**METROPOLITAN GOVERNMENT OF NASHVILLE AND DAVIDSON COUNTY**

**STAFF RECOMMENDATION**  
**1013 Paris Avenue**  
**July 18, 2018**

**Application:** New Construction - Addition  
**District:** Waverly-Belmont Neighborhood Conservation Zoning Overlay  
**Council District:** 07  
**Map and Parcel Number:** 118010242.00  
**Applicant:** Martin Wieck, Nine 12 Architects  
**Project Lead:** Jenny Warren, jenny.warren@nashville.gov

**Description of Project:** The application is for a rear and side addition.

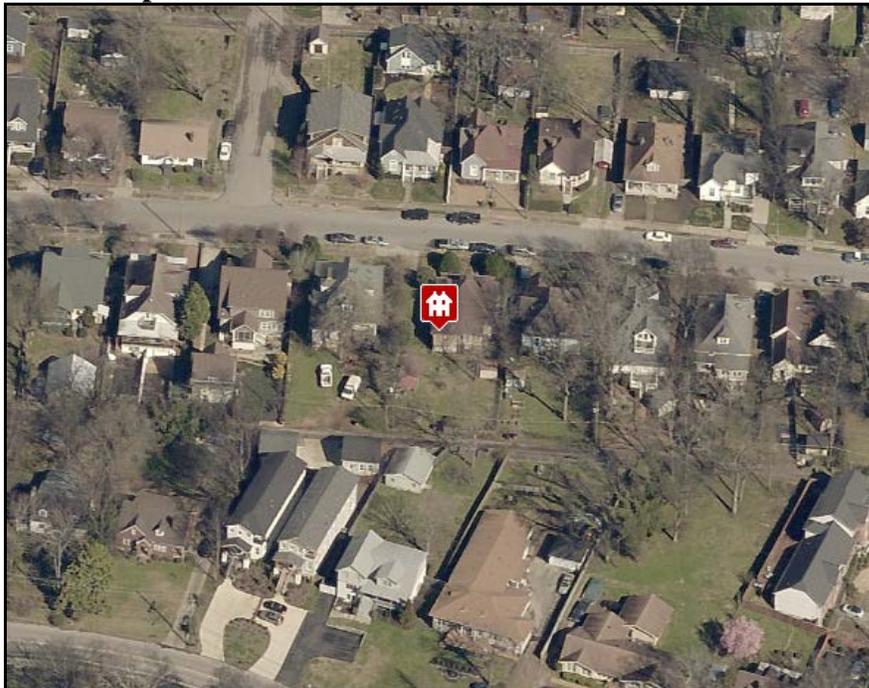
**Recommendation Summary:** Staff recommends approval of the addition with the condition that Staff provide final review of the roofing color, windows, rear door and screen porch posts, finding that the project meets the design guidelines for the Waverly-Belmont Neighborhood Conservation District.

Figure 3: Proposed west elevation, arrow indicates one-story side addition.

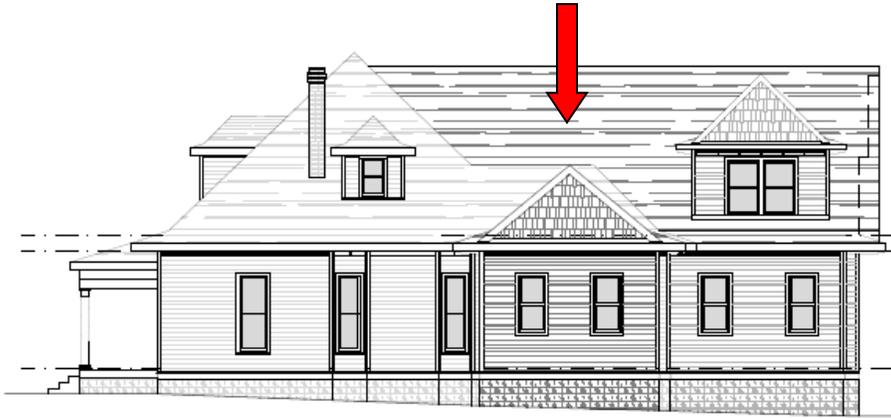
Height & Scale: The ridge of the proposed addition is approximately twenty-nine feet (29’) high, which is about one foot, two inches (1’2”) shorter than peak of the historic rooftop, all measured from finished floor height.

The depth of the addition is compatible with the historic house. The house is currently approximately forty-eight feet (48') deep, as measured from the front wall, and the addition will add about another eighteen feet (18') of total depth.

The side addition, as further described below, meets the guidelines for side additions in terms of its width, height, roof shape and location.

The project meets section III.A and B for height and scale and section IV.B. for additions-massing.

Figure 7: East elevation. The two openings proposed for alteration have been indicated.

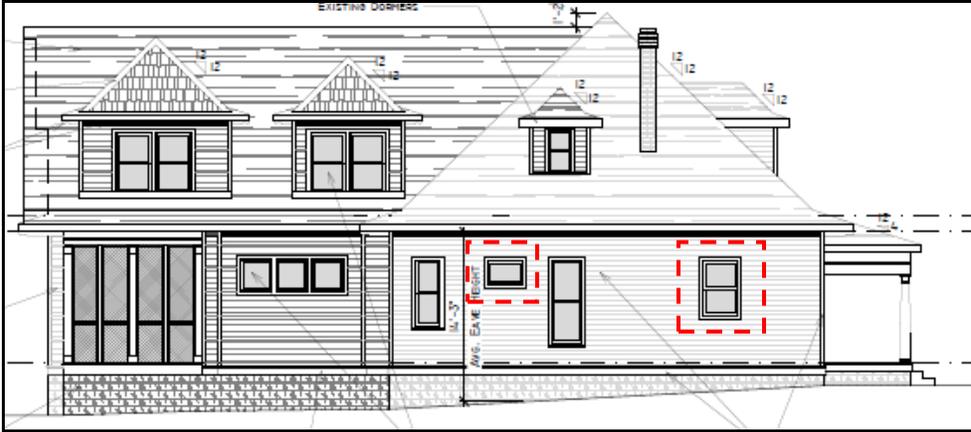
**Proportion and Rhythm of Openings:** On the east elevation, two changes are proposed: a door near the front of the house will be changed into a window and an existing window, near the rear of the house, will be shortened. Staff finds that converting the door to a window is appropriate, as the existing door is not original and likely was a window. Reducing the size of the third window is also appropriate, as this window is beyond the midpoint of the house and may not be original either, given its proportions in comparison to the other windows. The windows on the proposed addition are all generally twice as tall as they are wide, with the exception of the three small square windows at the master bedroom. Staff finds these to be appropriate as they are only used in one place and are well set back from the front of the house. There are no large expanses of wall space without a window or door opening. Staff finds the project’s proportion and rhythm of openings to meet Section III.G. for new construction-proportion and rhythm of openings.

**2 EAST ELEVATION**  
SCALE: 1/8"=1'-0"

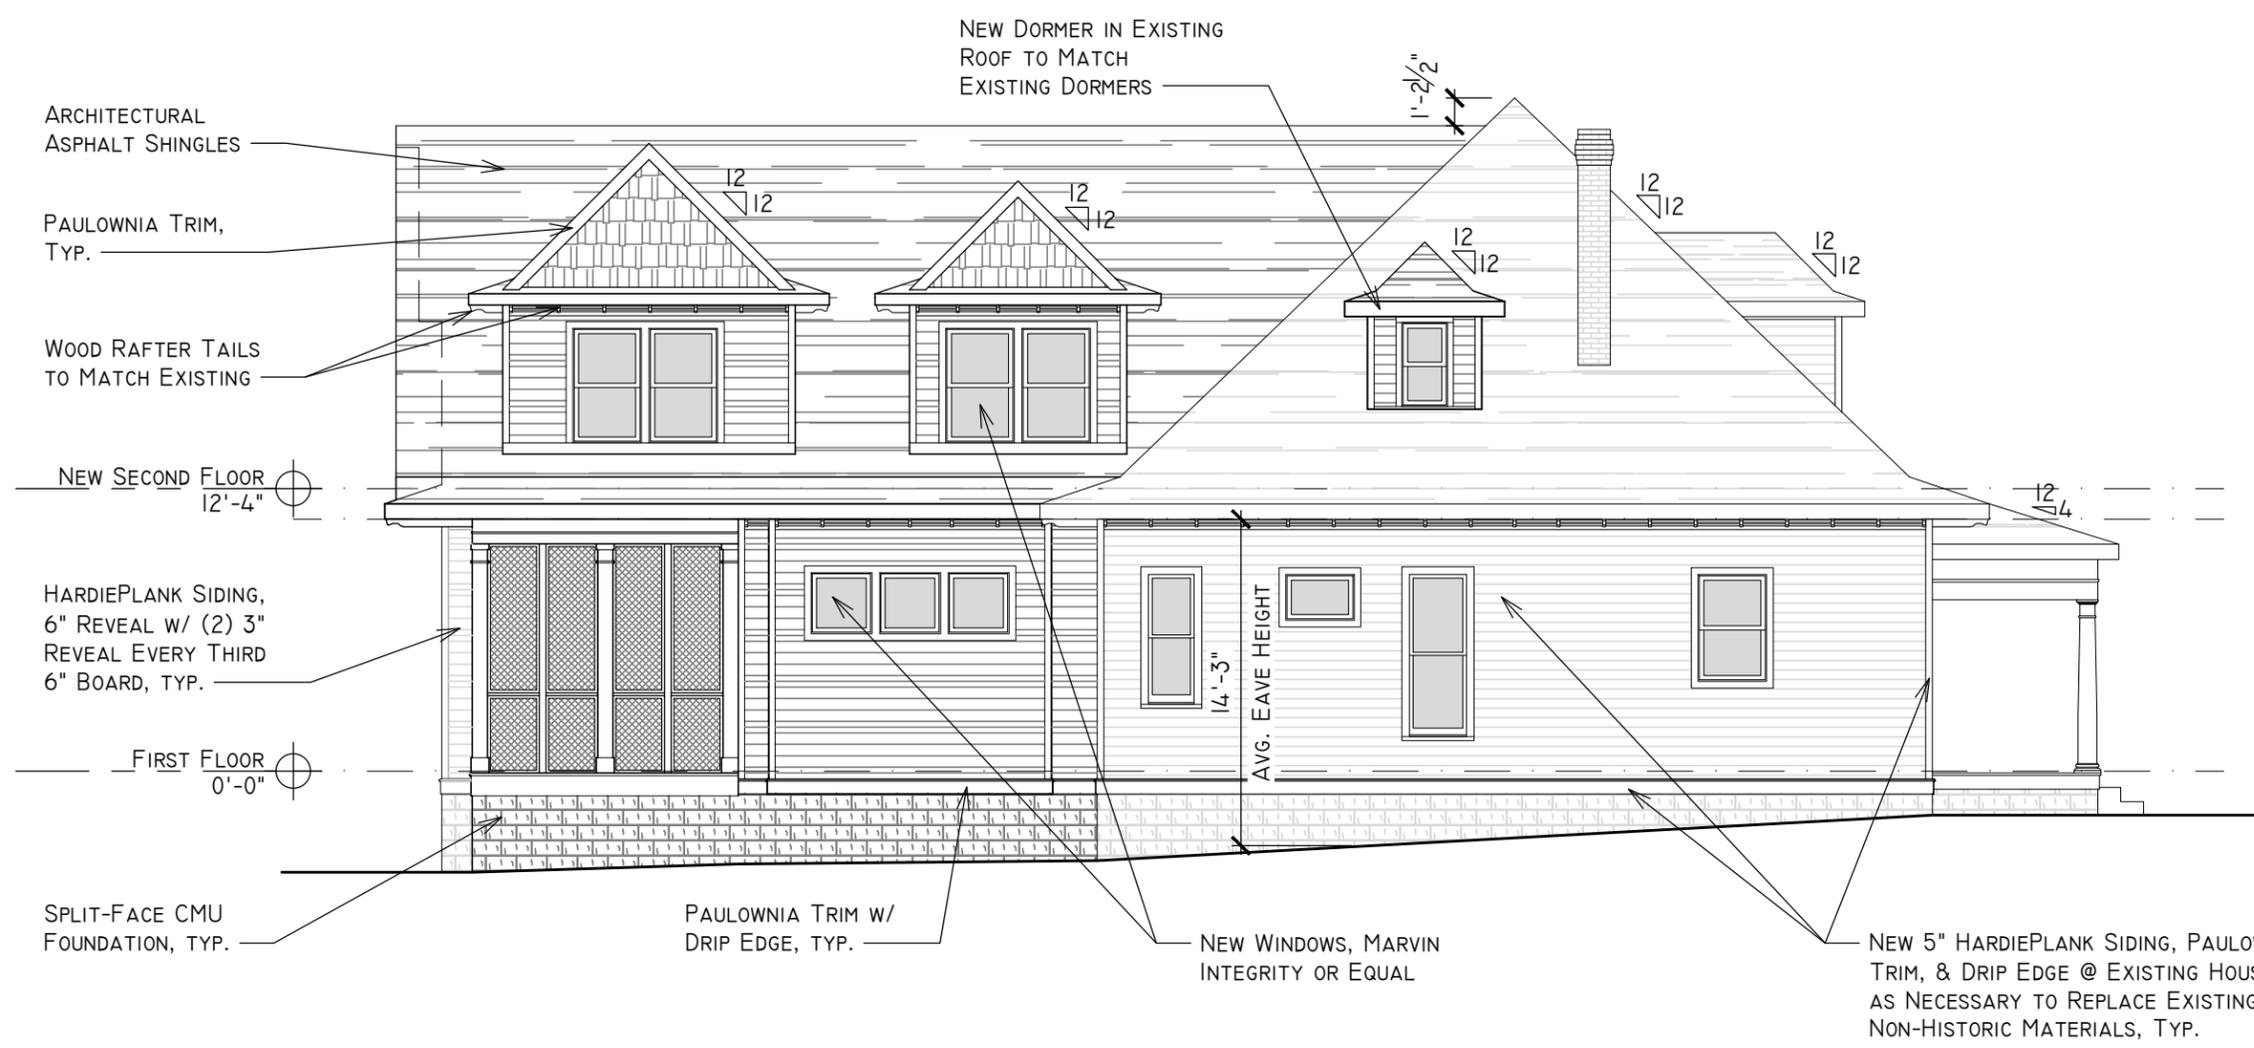
A new dormer is being added to the historic roof on the east elevation, where there is currently no dormer. As per section IV.C of the design guidelines, this new dormer will be similar in design and scale to the existing dormer on the west elevation.
